Seismic Walkdown Checklist (SWC)

Equipment ID No. ODG012 Equip. Class¹² (17) Engine Generators

Equipment Description E4 Standby Diesel Generator

Peach Bottom Atomic Power Station Unit 3
MPR-3812, Revision 3
Correspondence No. RS-12-173

Equipment ID: ODG012

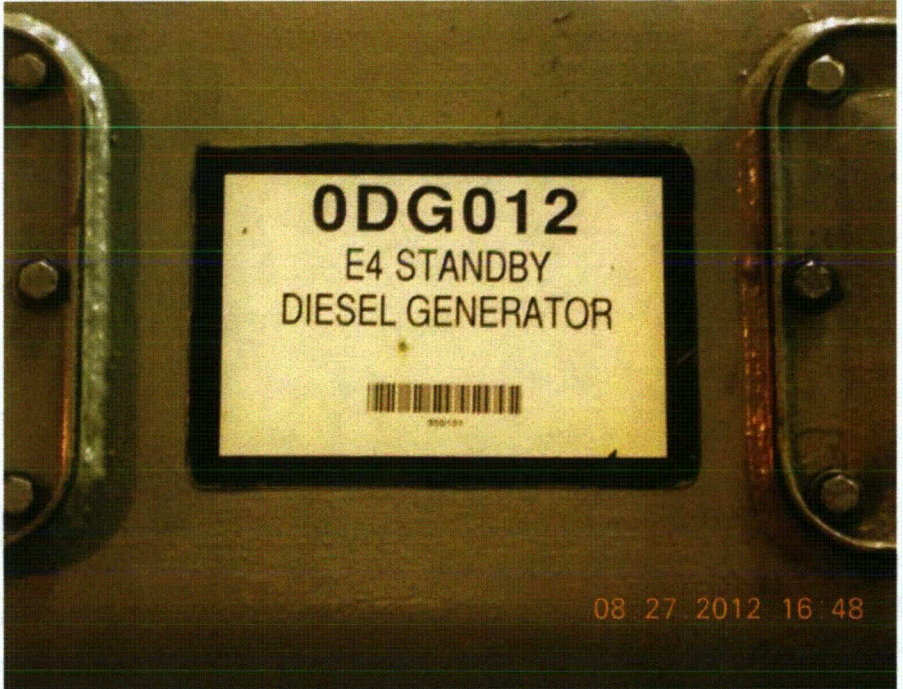
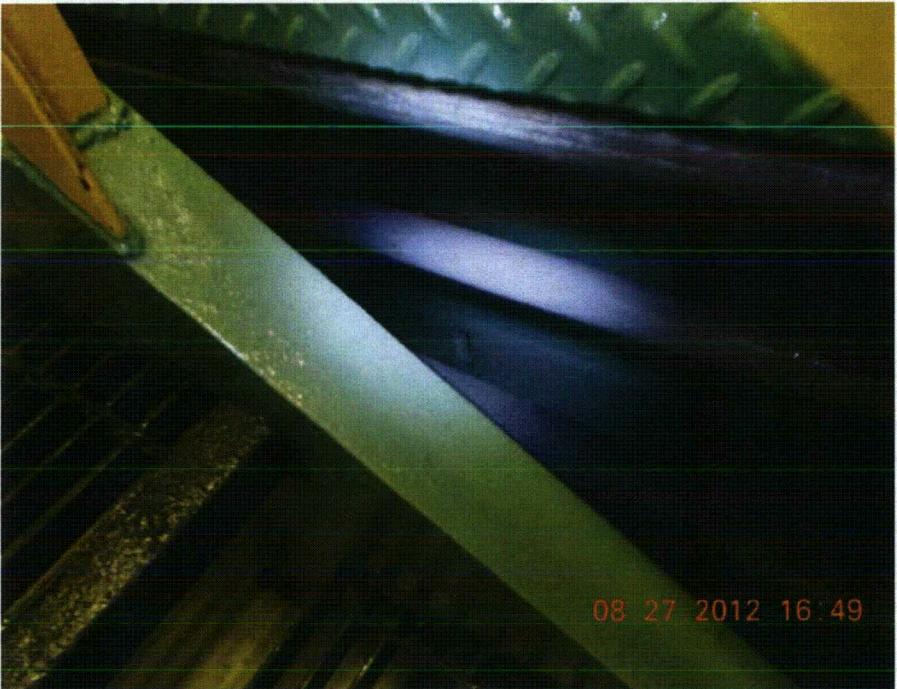
Does not match configuration evaluated in Calculation No. 6280-ES-155-1 (Rev. 1); as-built configuration has 1" anchor bolts securing skid to foundation instead of evaluated 1 1/4" anchor bolts. Judged acceptable for anticipated seismic loads per attached evaluation.

ANCHOR BOLT SIZE DISCREPANCY DOCUMENTED IN IR # 01438055 K6 11/9/12

7. Are soft targets free from impact by nearby equipment or structures? Y N U N/A
 TEMPERATURE GAUGE ON SCAVENGING AIR COOLER INLET COULD CONTACT ADJACENT LINE AND HOUSING COULD CRACK. WILL NOT AFFECT SAFETY FUNCTION
8. Are overhead equipment, distribution systems, ceiling tiles and lighting, and masonry block walls not likely to collapse onto the equipment? Y N U N/A
 FLUORESCENT LIGHT TUBES FALLING JUDGED CREDIBLE, BUT NOT SIGNIFICANT
9. Do attached lines have adequate flexibility to avoid damage? Y N U N/A
10. Based on the above seismic interaction evaluations, is equipment free of potentially adverse seismic interaction effects? Y N U

DIESEL GENERATOR HOLDDOWN BOLTS

DESIGNED AS $1\frac{1}{4}$ " \varnothing BOLTS

AS FOUND 1 " \varnothing BOLTS

TENSILE STRESS AREA FOR $1\frac{1}{4}$ " BOLTS = 0.969 in^2 (CALC 6280-ES-155-1)

PRIMARY TENSILE LOAD STRESS IN BOLT IS 0 SINCE NO UPLIFT
 PER CALC 6280-ES-155-1.

SHEAR STRESS IN $1\frac{1}{4}$ " BOLT = 2.02 ksi (CALC 6280-ES-155-1)

$$\text{SCALING BY } 0.625 = \frac{1}{0.625} \times 2.02 \text{ ksi} = 3.23 \text{ ksi}$$

SHEAR STRENGTH
~~PROOF~~ LOAD IN CALC IS $33,000 \text{ psi}$

STRESS IS MUCH LOWER THAN ALLOWABLE: OK

MAX TOTAL SHEAR LOAD (12 BOLTS) = $23,479 \text{ lb}$ (CALC 6280-ES-155-1)

$$\text{SHEAR LOAD PER BOLT} = \frac{23,479 \text{ lb}}{12} = 1957 \text{ lb}$$

SHEAR IS MUCH LESS THAN ALLOWABLE. ~~NEGLECTING PRE~~
 THEREFORE, ANCHOR BOLTS ARE OK.
